**RE: SUPPLEMENTAL REQUEST FOR STAFF APPROVED PROJECT  
MODIFICATION: WALNUT ENERGY CENTER AUTHORITY WALNUT  
ENERGY CENTER (02-AFC-4C): INSTALLATION OF MICRO FILTER FEED  
TANK AND SHADE STRUCTURE**

With this background, the purpose of this Supplemental Request is to obtain Energy Commission Staff approval for the following modifications to the WEC: (1) the addition of a new Micro Filter Feed Tank, and (2) the addition of a new Shade Structure to cover other portions of the Zero Liquid Discharge (“ZLD”) system. As described below, the Micro Filter Feed Tank is needed for WEC to continue to effectively operate its ZLD water treatment process. The Shade Structure is necessary to prevent sun damage to certain other components of the ZLD system.

**ATTACHMENT 1**  
**FIGURE 2**  
**CERTIFIED FOR CONSTRUCTION DRAWING OF THE**  
**MICRO FILTER FEED TANK**

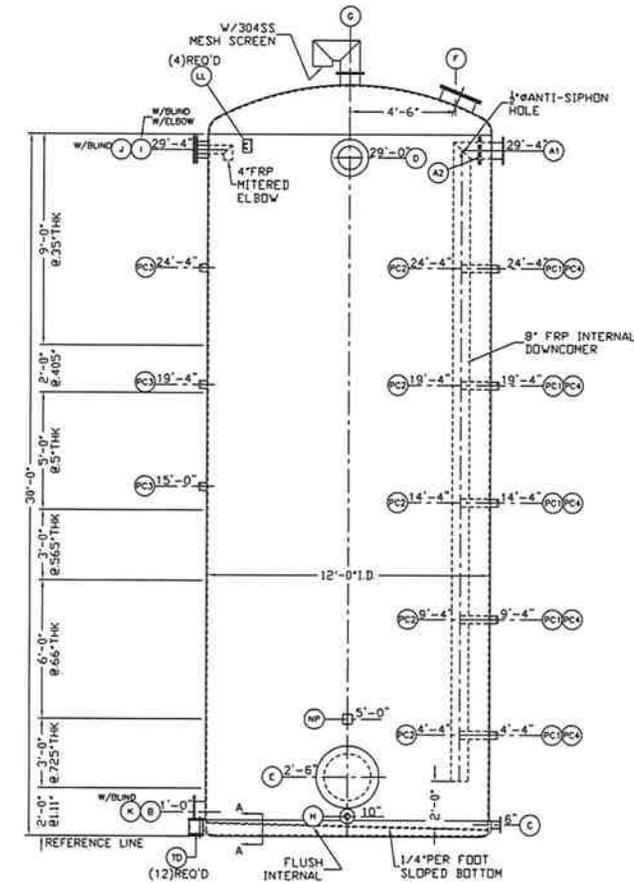
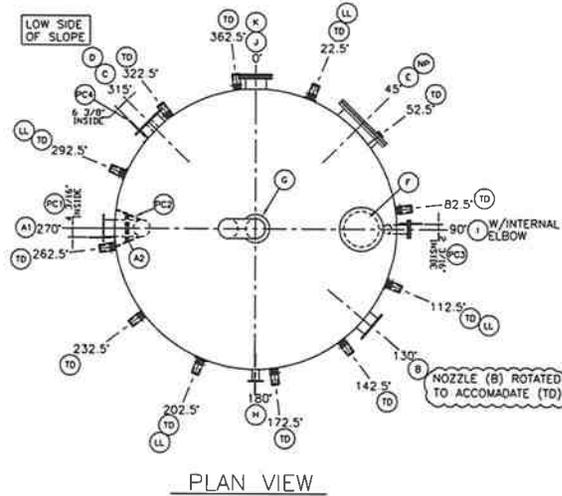
The Micro Filter Feed Tank is a 24,000 gallon fiberglass tank (12' diameter x 30' in height). It is gray in color, matching the other structures at the WEC, and is located in the ZLD water treatment process area. This new tank is not clearly visible from outside of the plant property. The Micro Filter Feed Tank was sized to meet the design requirements of the new micro filtration equipment and stores the cooling tower blowdown for use in the micro filters. The tank provides enough storage to handle brief upsets in the micro filters without affecting the cooling tower chemistry.

Included in Attachment 1 are four figures that depict the tank location and dimensions. Figure 1 shows the new Micro Filter Feed Tank, the tank in the middle of the three tanks shown. The Micro Filter Feed Tank is approximately 2 feet shorter than the HERO Reject Storage Tank (on the right side in the picture). Figure 2 is a "Certified for Construction" drawing of the Micro Filter Feed Tank that shows its dimensions. The Certified for Construction designation is set forth in the "Revisions" table, dated July 13, 2009.<sup>1</sup> Figure 3 is As Built drawing for the Micro

**ATTACHMENT 1**  
**FIGURE 3**  
**AS BUILT DRAWING FOR THE MICRO FILTER TANK**  
**FOUNDATION PLAN AND DETAILS**

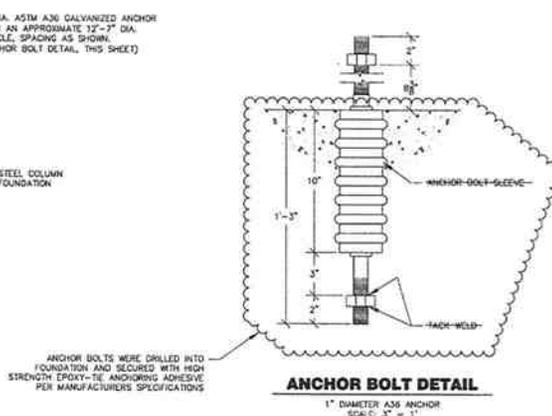
Filter Tank Foundation Plan and Details. Figure 4 is an aerial of the WEC plant showing the locations of the Micro Filter Feed Tank and the “Shade Structure” described below. Finally, Appendix A is a memorandum from a Professional Engineer of the District’s Civil Engineering and Water Resources Administration Department documenting the reports and inspections associated with the “Microfiltration Feed Tank and Concrete Foundation.” This memorandum confirms, among other things, “During the construction and installation, Civil Engineering staff was present to observe soil compaction underneath the concrete foundation, formwork, rebar installation, concrete finishing, and installation of the feed tank and steel anchors.”

AERIAL OF THE WEC PLANT SHOWING THE  
LOCATIONS OF THE MICRO FILTER FEED TANK AND  
THE “SHADE STRUCTURE”

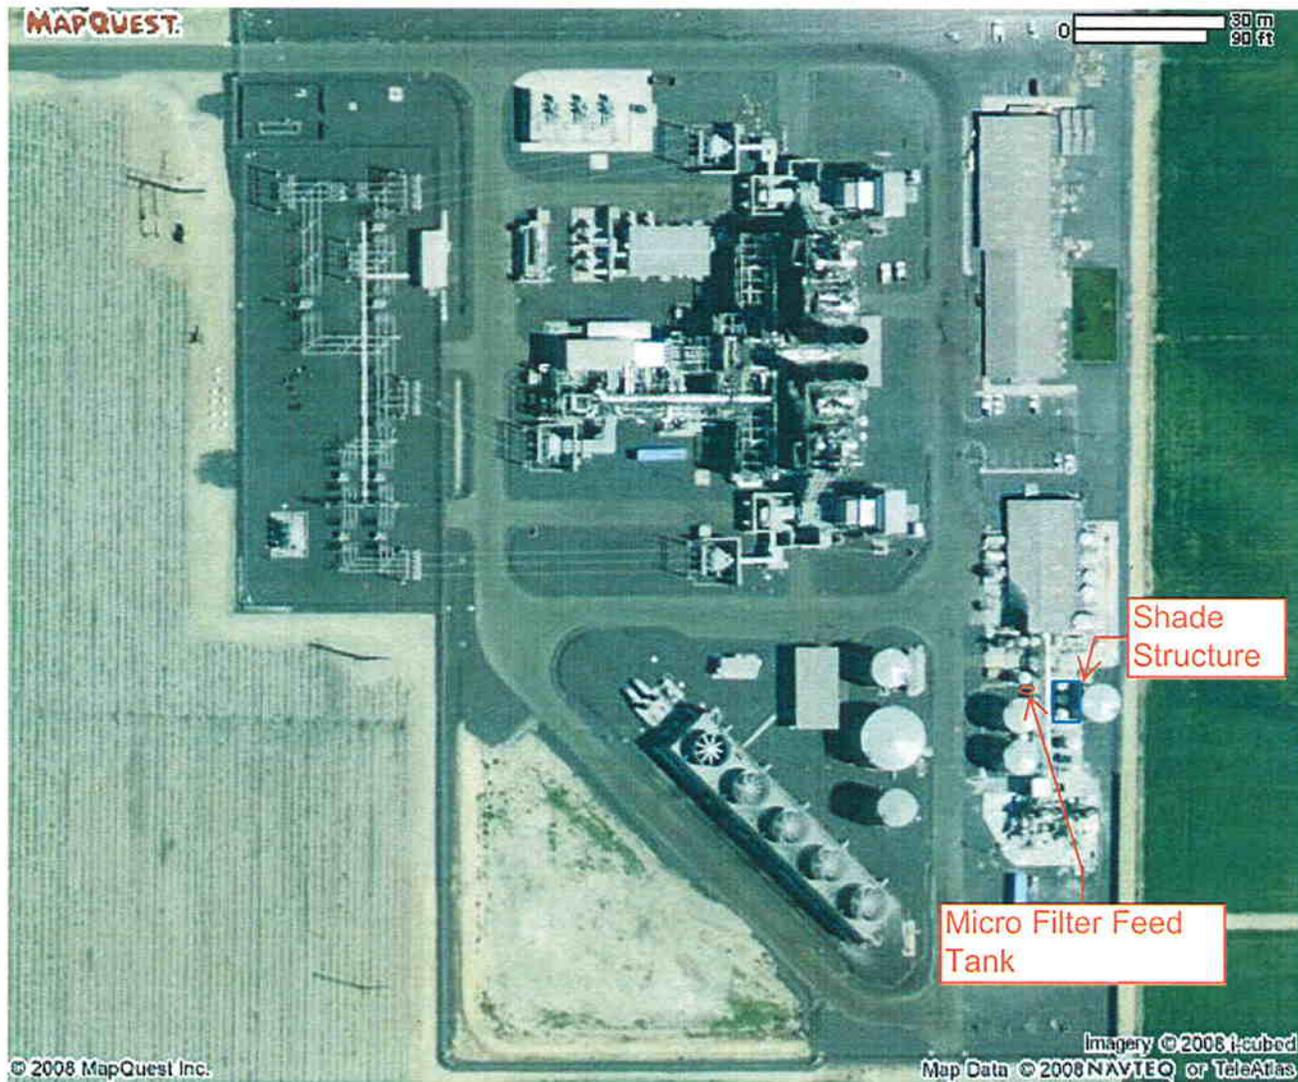
TID proposes to install the Shade Structure to protect specific components of the micro filtration equipment from sun damage. As shown in Attachment 1, Figure 4, the Micro Filter Feed Tank will not be covered by the Shade Structure. Instead, the Shade Structure will be built above certain Micro Filtration equipment, specifically, the Micro Filter membranes, pumping equipment and electrical controls. The primary purpose of the Shade Structure is to protect the Micro Filtration membranes from the damaging effects of sunlight and UV rays.

**ATTACHMENT 2**  
**ENGINEER-STAMPED DRAWING OF THE**  
**SHADE STRUCTURE – PAGES 1 & 2**

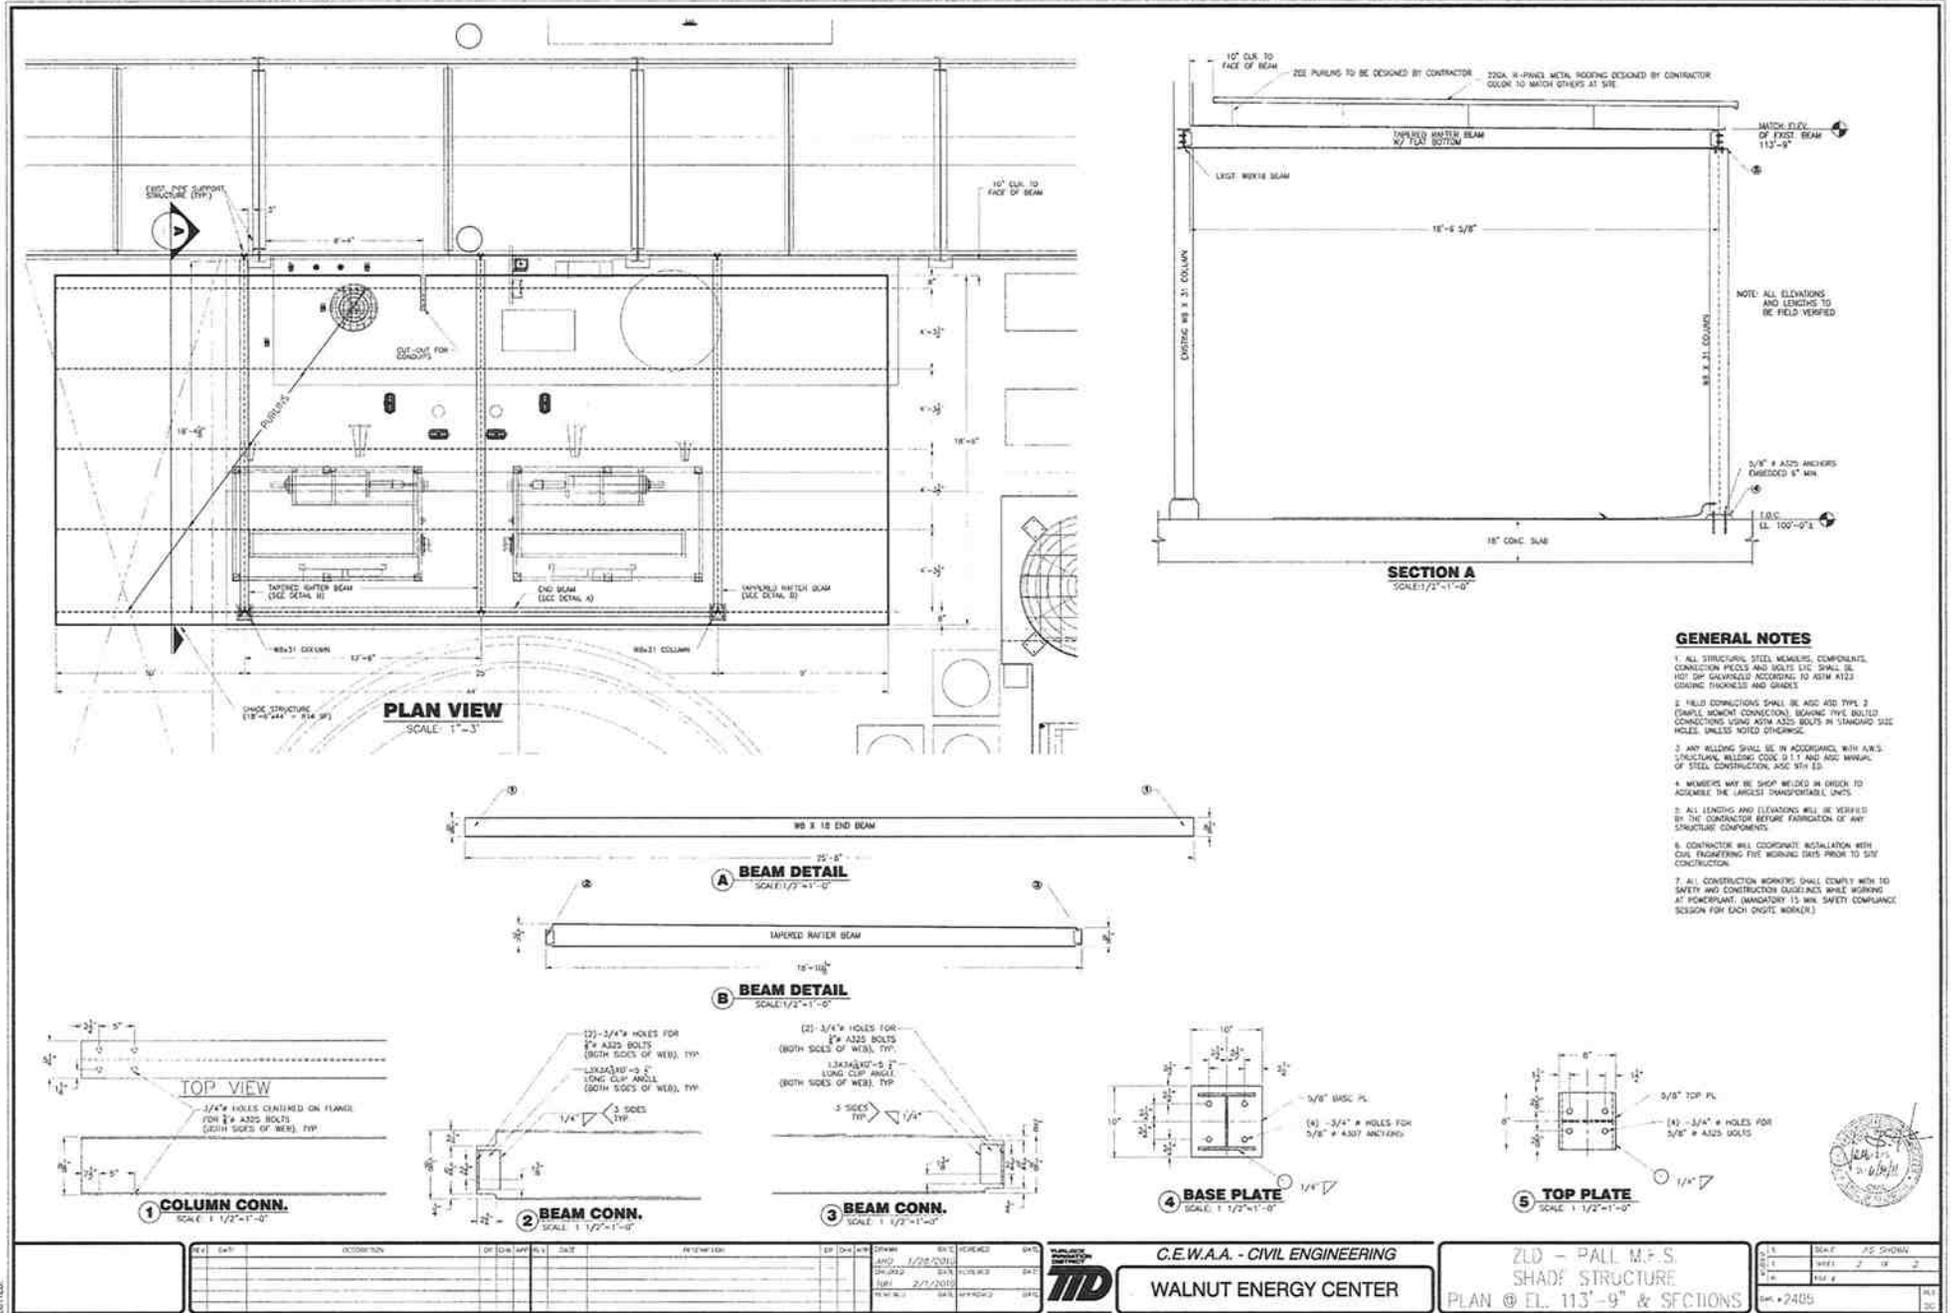
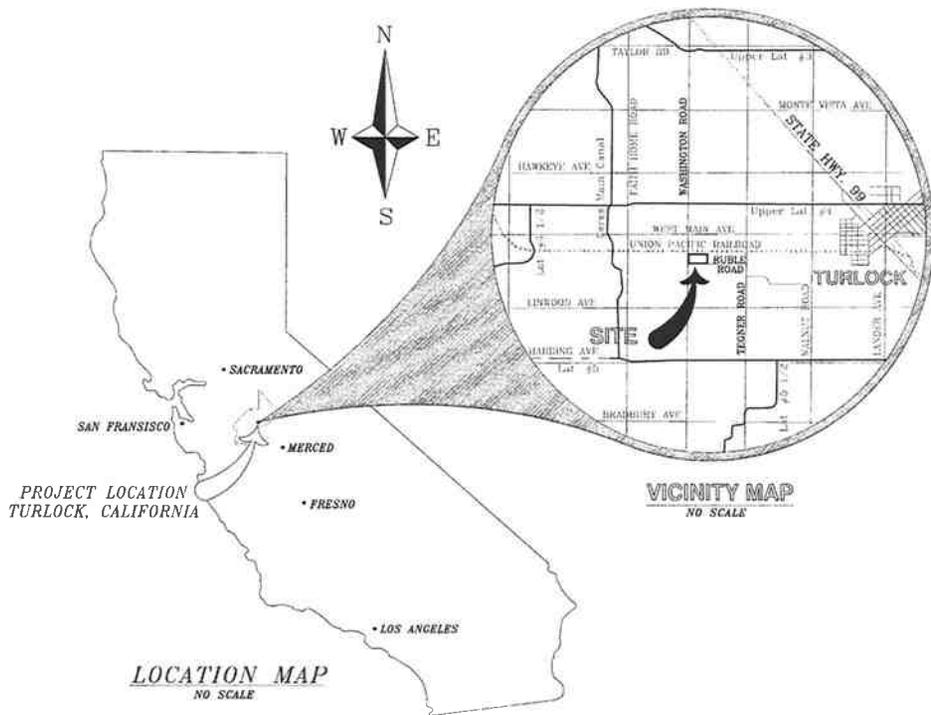
The Shade Structure would be 44’ long by 18’6” wide and approximately 13’ in height. The equipment and smaller ZLD system tanks that would be protected by the Shade Structure are approximately 7 feet in height. The Shade Structure would be supported by galvanized steel beams and the metal roof would be painted gray to match the rest of the WEC. Attachment 2 is a two-page, Engineer-stamped drawing of the Shade Structure.
